Access Compliance Report

Public Rights-of-Way

(Curb Ramps)

Intersection ID: 13714	Main Street: HANOVER_ST	Cross Street: MCCLINTOCK_RD	Location: W
ADA ID: 84DA08C47939	Ramp Type: Perp	Initial Pass/Fail: Fail	Overall Compliance: No
Codes/Mitigation Info/Possible Solution			Severity Score: 10
			Field Measurements/Component Compliance

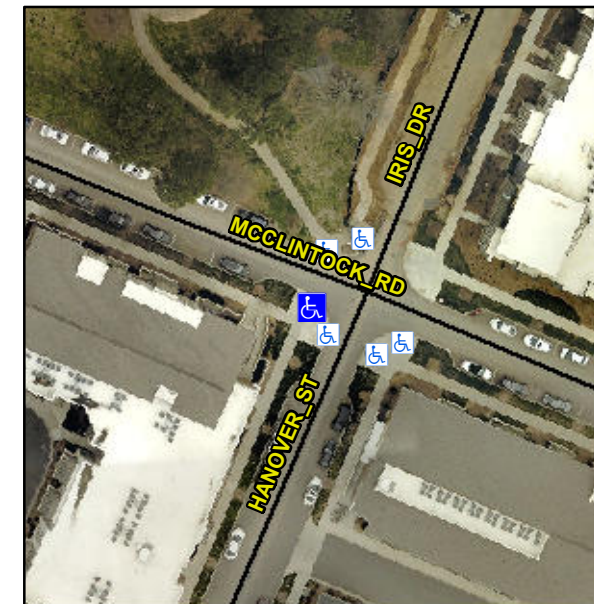
R304.5.1, R304.5.3

Compliance	Description	Data	Compliance	Description	Data
N/A	Ramp Length (in)	84.0	Yes	Ramp Slope (%)	6.2
No	Ramp Width (in)	47.5	No	Ramp XSlope (%)	3.4
N/A	Flare Type LT	N/A	N/A	Flare Type RT	N/A
N/A	Flare Slope LT (%)	N/A	N/A	Flare Slope RT (%)	N/A
N/A	Flare Traversable LT?	N/A	N/A	Flare Traversable RT?	N/A
N/A	Landing Length (in)	N/A	N/A	DWS Provided?	N/A
N/A	Landing Width (in)	N/A	N/A	DWS Contrast?	N/A
N/A	Landing Slope (%)	N/A	N/A	DWS Length (in)	N/A
N/A	Landing X Slope (%)	N/A	N/A	DWS Full Width?	N/A
N/A	Landing Curb? (Y/N)	N/A	N/A	DWS Offset (in)	N/A
N/A	Shared Landing?	N/A			
N/A	Gutter Ponding?	N/A	N/A	Gutter Slope (%)	N/A
N/A	Gutter Lip Ht (in)	N/A	N/A	Gutter X Slope (%)	N/A
N/A	Painted X Walk1?	No	N/A	Painted X Walk2?	N/A
	X Walk 1 Direction	To N		X Walk 2 Direction	N/A
N/A	X Walk 1 Width (in)	N/A	N/A	X Walk 2 Width (in)	N/A
	X Walk 1 Slope (%)	2.2		X Walk 2 Slope (%)	N/A
	X Walk 1 X Slope (%)	0.8		X Walk 2 X Slope (%)	N/A

Remove & Replace Entire Ramp.
